SEWAGE DISPOSAL PERMIT

RE: Septic Permit S2021-0103 – Conditions of Approval
3974 Ciarlo Lane, Vacaville CA 95688, APN 0105-040-420 – see also B2021-0531

SEWAGE DISPOSAL SYSTEM PERMIT APPLICATION

OVERALL SITE PLAN
SCALE: 1" = 100'

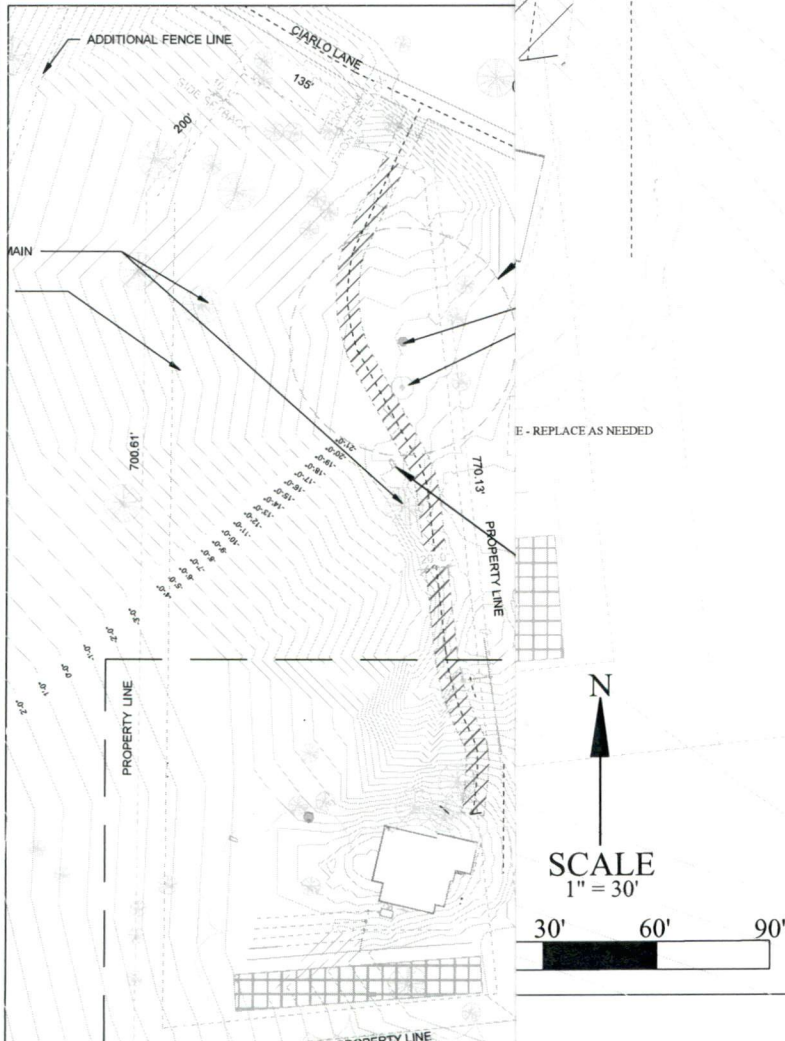
Approval for S2021-0103 is forwarded with the following conditions:

1. Pre-construction meeting requirement:
Please contact Environmental Health at 707.784.1636 at least 24 hours in advance to schedule a pre-construction meeting prior to commencing construction of the leachfield expansion.
2. The leachfield expansion shall meet the minimum 25 ft. property line setback

1. The approved expansion of the existing septic system shall take the form of at least 225 lineal feet of 36 inch wide by 36 inch deep conventional leachline trench, tied into the end/last d-box of the existing system.

2. Any deviations from the approved plans will require prior approval from Ex Wastewater Design and Environmental Health
3. Any deviations from the approved plans will require submittal of "as-built" plans to document the revision
